## Report on Review of Bay Delta Conservation Program Modeling

Since December 2012, MBK Engineers and Dan Steiner (collectively “Reviewers”) have assisted various parties in evaluating the operations modeling that was performed for the Bay Delta Conservation Plan (BDCP). To assist in understanding BDCP and the potential implications, stakeholders<sup>1</sup> requested that the Reviewers review the CalSim II modeling studies performed as part of the BDCP (hereafter “BDCP Studies” or “BDCP Model”).

This Report summarizes: (1) the Reviewers’ independent analysis and review of the BDCP Model, publicly released for the BDCP’s Draft EIR/S in December 2013, (2) the Reviewers’ updates and corrections made to the BDCP Model, and (3) comparisons between the original BDCP Model and the independent Model as revised by the Reviewers.

Figure 22. Alt 4-ELT North Delta Diversion Versus South Delta Diversion for July, August, and September

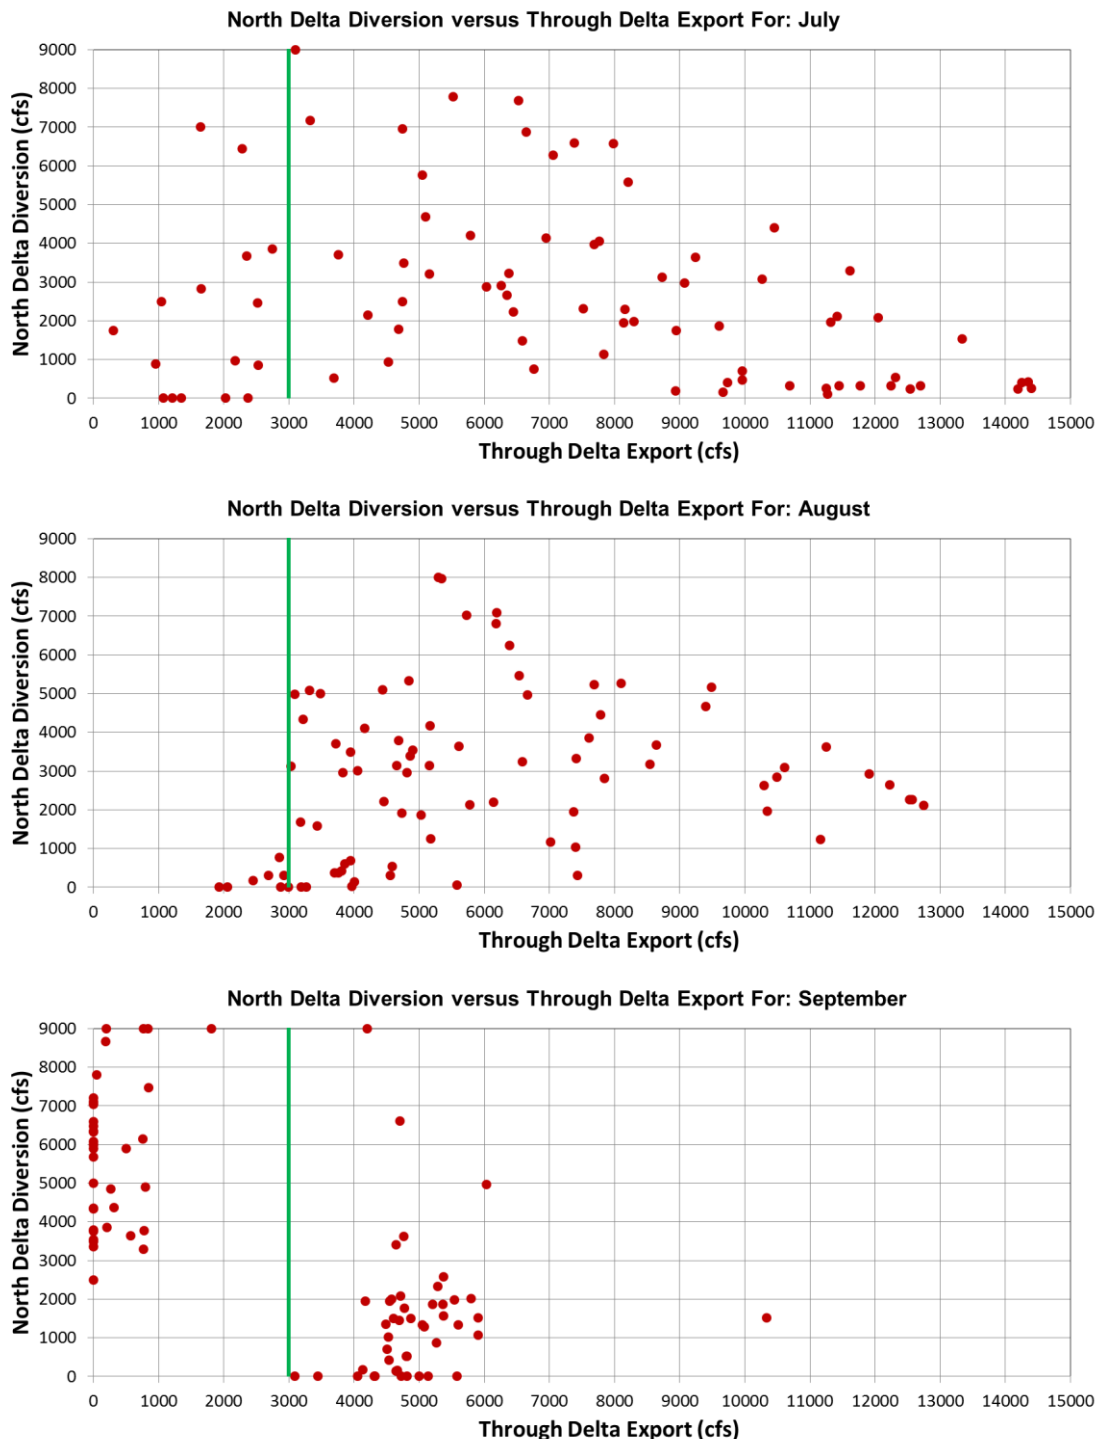
Figure 22 contains figures for July, August, and September for Alt 4-ELT that plot NDD against SDD. In the months of July to September SDD are occasionally very high, exceeding 14,000 cfs in July, with minimal NDD. This occurs due to outdated model code that imposes an instream flow requirement in Sacramento River flow below Hood in excess of the bypass criteria prescribed in the BDCP. There are numerous occurrences when bypass flows prescribed in the BDCP are exceeded and SDD are higher than expected. On the other hand, there are also many times when NDD are above minimum pumping levels and SDD are below the BDCP prescribed 3,000 cfs threshold indicated by the green line in Figure 22. For unknown reasons, the model code requiring SDD to be greater than 3,000 cfs before NDDs occur from July through September is deactivated in the BDCP modeling of this Alternative.

Figure 23. South Delta Diversion at Banks

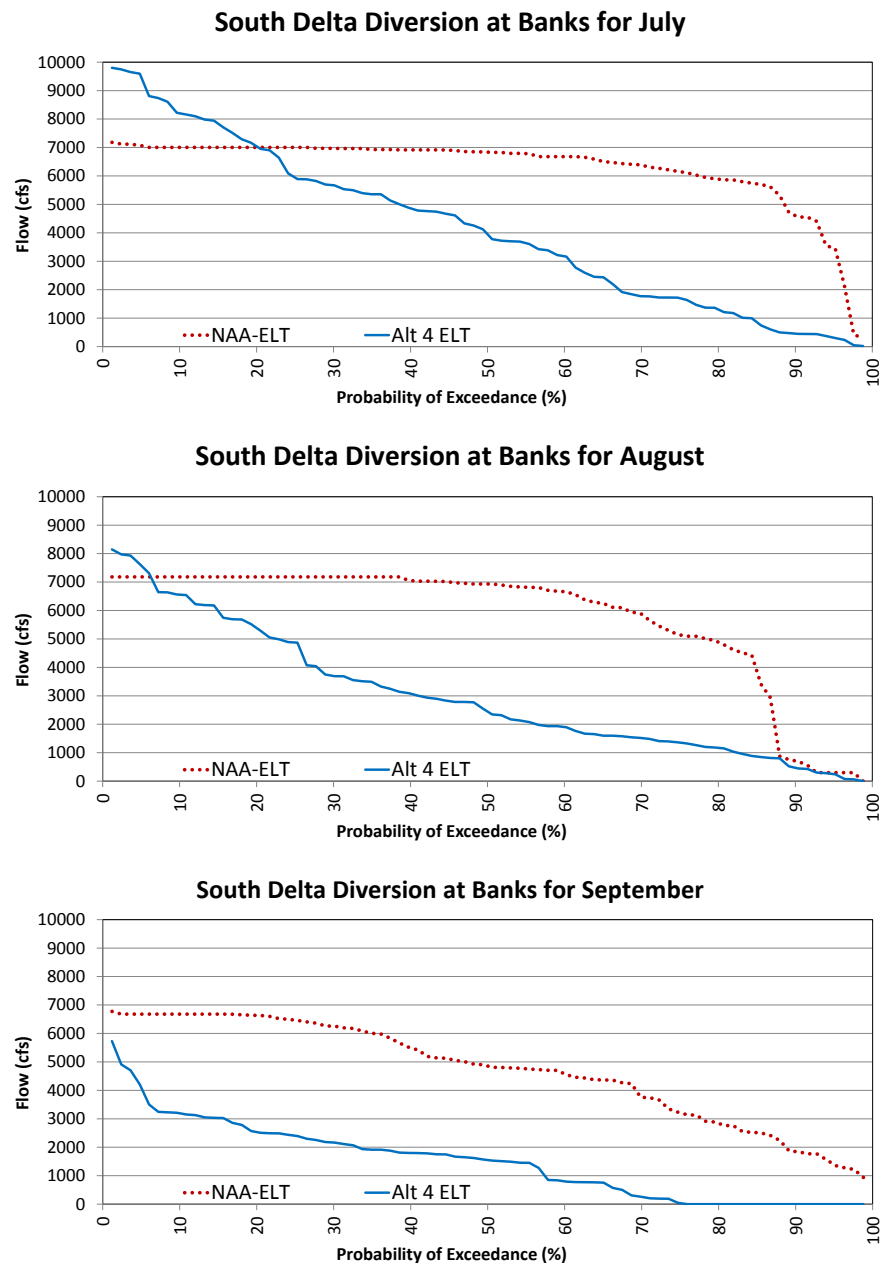
South Delta Diversion at Banks is not limited to existing permit capacity of 6,680 cfs and pumping may reach full capacity of 10,300 cfs in July, August, and September. Figure 23 contains exceedance probability charts of South Delta Diversion at Banks for July, August, and September. The chart for July shows SDD at Banks exceeding existing permit capacity 20% of years, in August this occurs in about 7% of years. There are South Delta diversions at Banks 25% of the time in September while diversions from the Sacramento River may range from 2,500 cfs to 7,500 cfs.

**Figure 24. Delta Outflow Change (Alt 4-ELT minus NAA-ELT)**

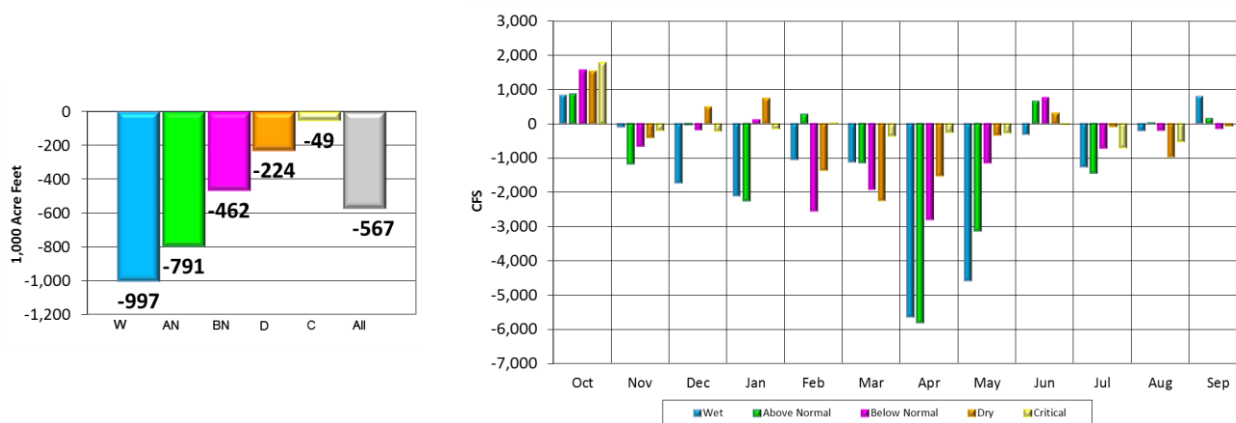
Figure 24 illustrates a comparison of Delta outflow between the NAA-ELT and Alt 4-ELT. Decreases in Delta outflow are the result of the CVP and SWP ability to increase Delta exports in Alt 4-ELT. The apparent increase in Delta outflow in October is partially due to additional export restrictions though Old and Middle River flow requirements. However, the increase in October Delta outflow is also due to an unrealistic operation of the Delta Cross Channel. The additional export restrictions cause the flow standards imposed at Rio Vista to be the controlling point in CVP and SWP operations; the water quality standards are all being met and do not require

flows above the amount needed to satisfy the Rio Vista standard. Meeting the Rio Vista flow standards without closing the Delta Cross Channel gate results in releasing more water from upstream reservoirs than would otherwise be necessary. This occurs because a certain amount of the water released to meet the Rio Vista flow standards would flow into the Central Delta at location of the Delta Cross Channel gate. This water would not make it to Rio Vista and therefore would not be counted towards meeting the Rio Vista flow standards. However, due to the BDCP model's assumed restrictions on exports at this time, this water could not be pumped from the South Delta facilities and thus ends up as "extra" Delta outflow. By closing the Delta Cross Channel gate, the operators would assure that all of the water released to meet the Rio Vista flow standards would be counted towards those standards. The BDCP model's assumptions that the Delta Cross Channel gate would not be closed are not practical or a sensible operation as the operators confirmed they would close the gate during these conditions to avoid the unnecessary loss of water supplies (as was done in October and November 2013). The assumption in the BDCP model to maintain the gate in the open position causes it to overstate the amount of Delta outflow.

Figure 44. Alt 4 North Delta Diversion Versus South Delta Diversion for July, August, and September

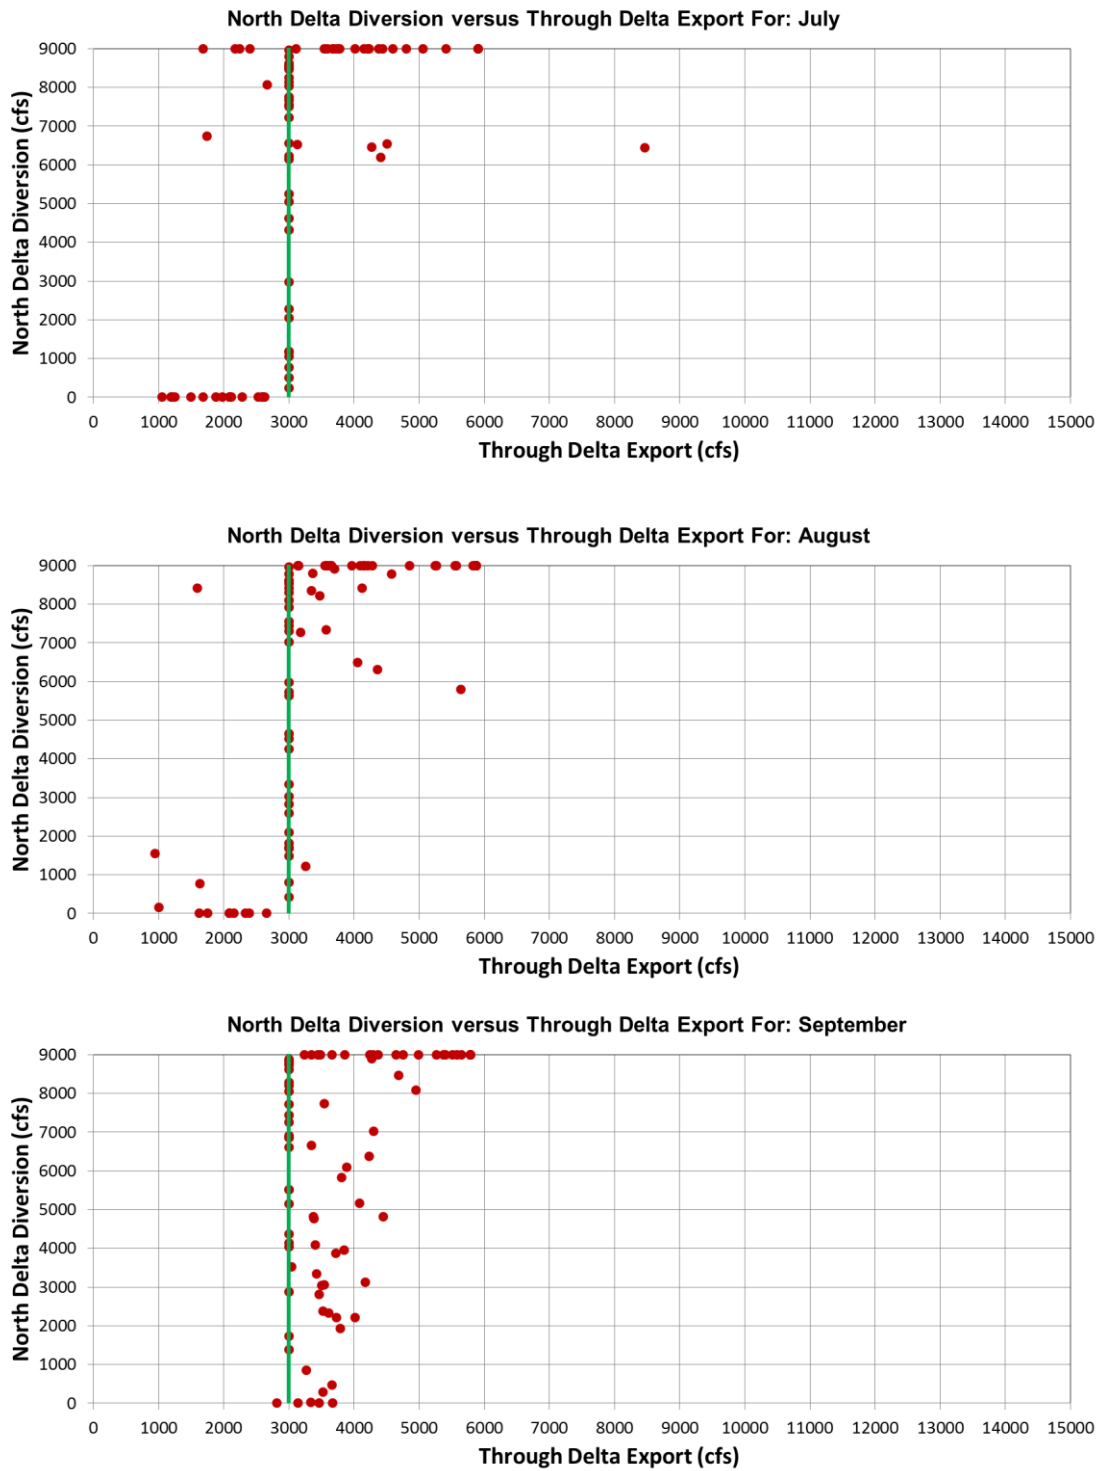
Figure 44 contains modeling results from Alt 4 for July, August, and September that plot NDD against SDD (Through Delta Export). There are many occasions when SDD are 3,000 cfs, which is due to criteria specifying that SDD during this time period need to be at least 3,000 cfs prior to diverting at the NDD facility. Although there are about six occurrences in July and three in August where the model did not satisfy this criterion, this issue has not yet been addressed for this modeling effort.

Figure 60. NDD, and Sacramento River Flow

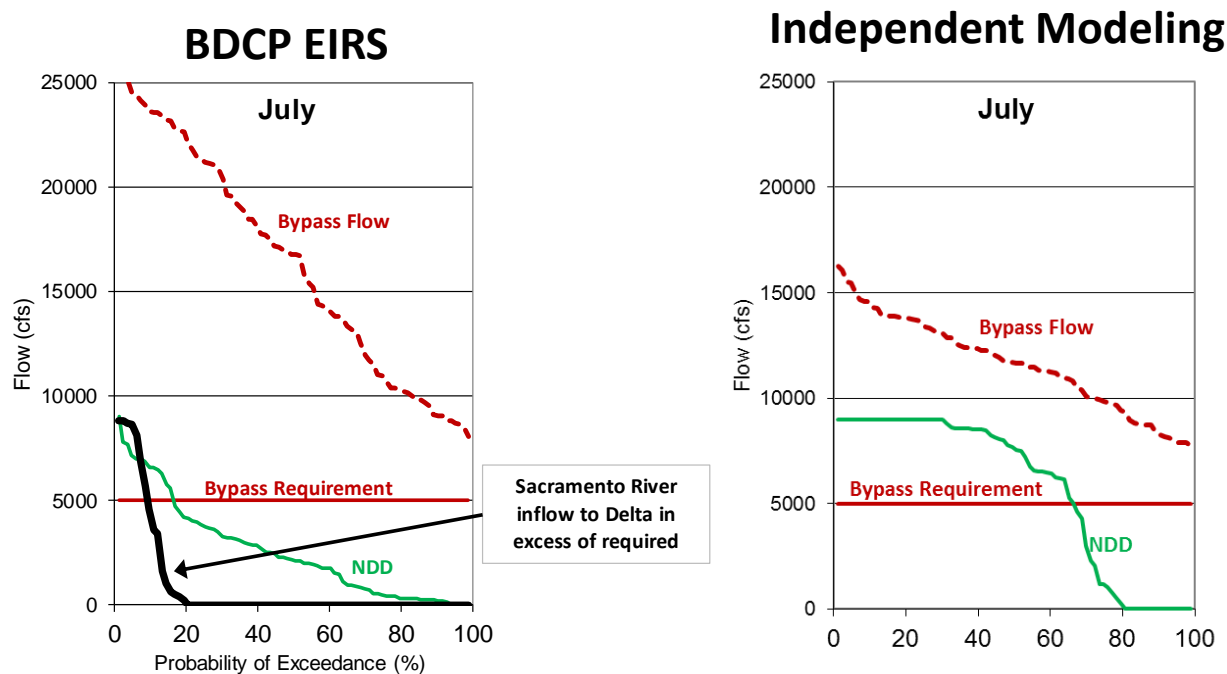
Independent modeling shows greater NDD during July and other months because the BDCP EIRS modeling includes artificially high Sacramento River bypass flow requirements. Figure 60 contains exceedance probability plots of Sacramento River required bypass, Sacramento River bypass flow, NDD, and excess Sacramento River flow to the Delta. As can be seen in Figure 60, bypass flow is always above the bypass requirement. The BDCP version of CalSim sets a requirement for Sacramento River inflow to the Delta that the independent modeling does not need in order to satisfy Delta requirements, therefore the NDD is higher in the independent modeling.
